ADDENDUM NUMBER 3  
TO THE DRAWINGS AND SPECIFICATIONS

PROJECT: McLean County Unit District No. 5 Kingsley Junior High School HVAC Renovation  
and Geothermal

A/E PROJECT NO: 23152318

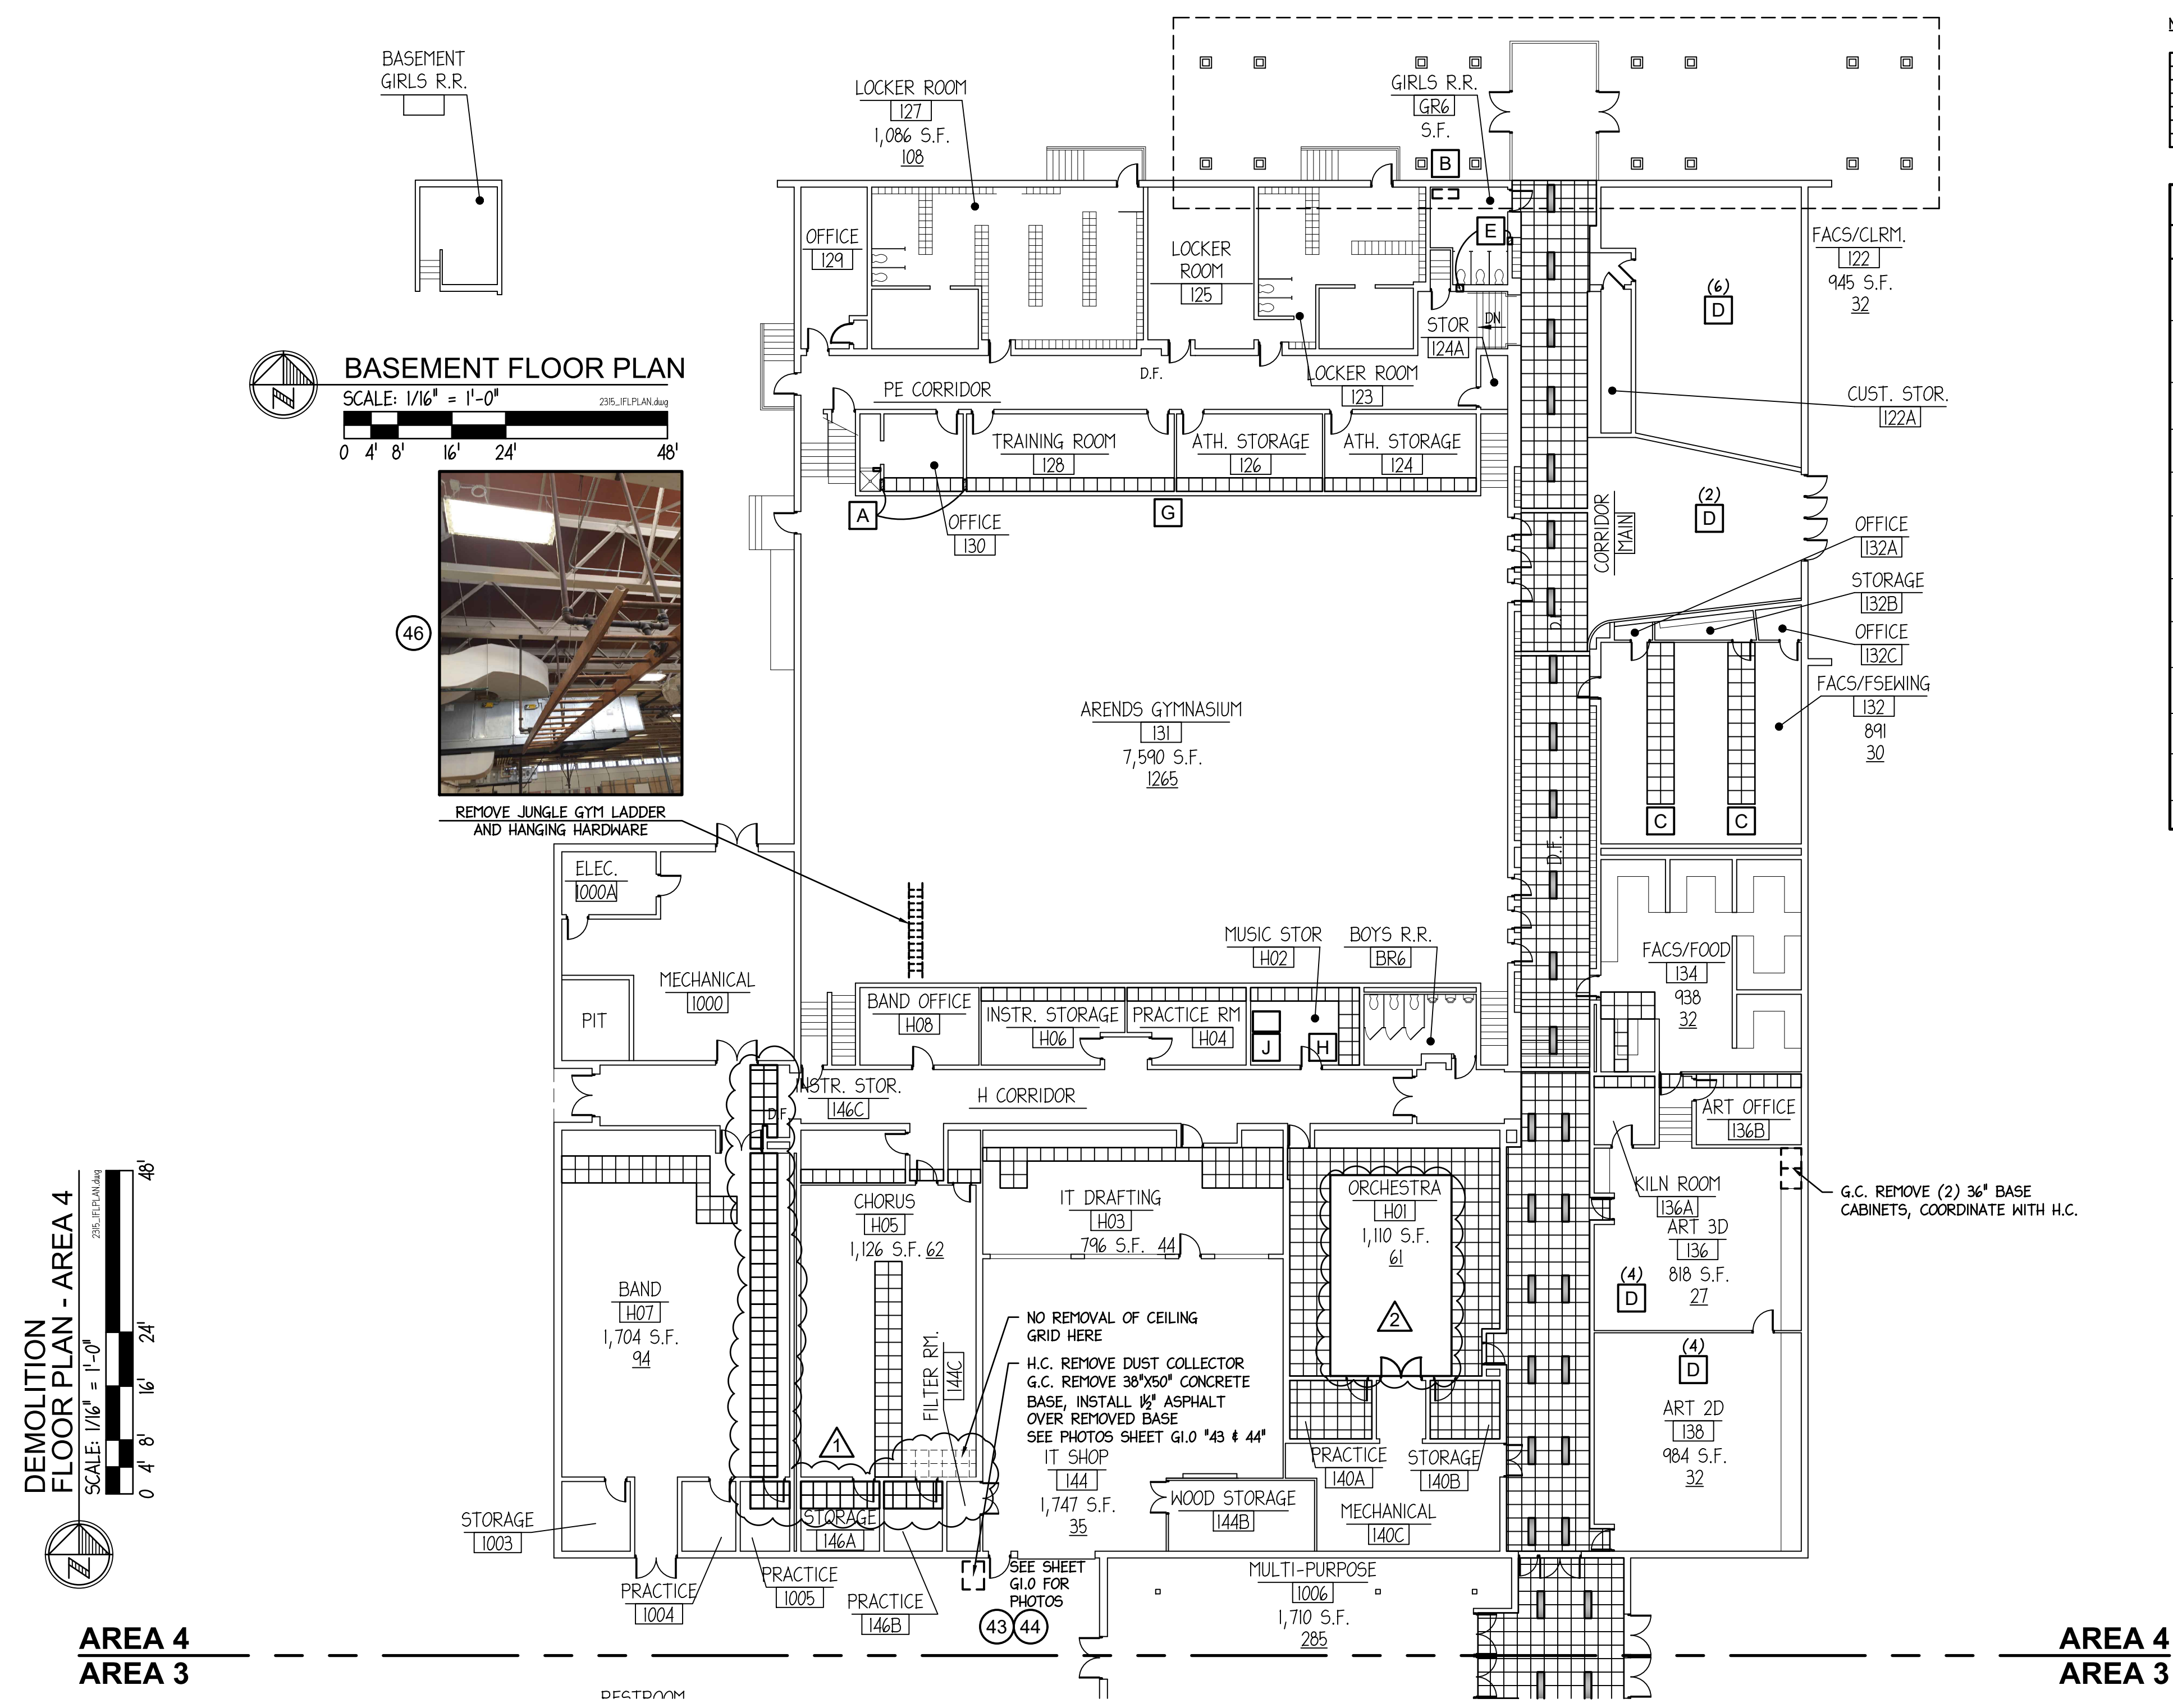
15. TO THE DRAWINGS, Sheet D1.1: Orchestra Room 140 (aka H01): Add to Base Bid document: Remove additional ceiling panels and grid 30' x 18'. Install new grid and ceiling panels when HVAC work is done in this room. This is added to the changes noted on Addendum 2 Items 4., 5., and 6.
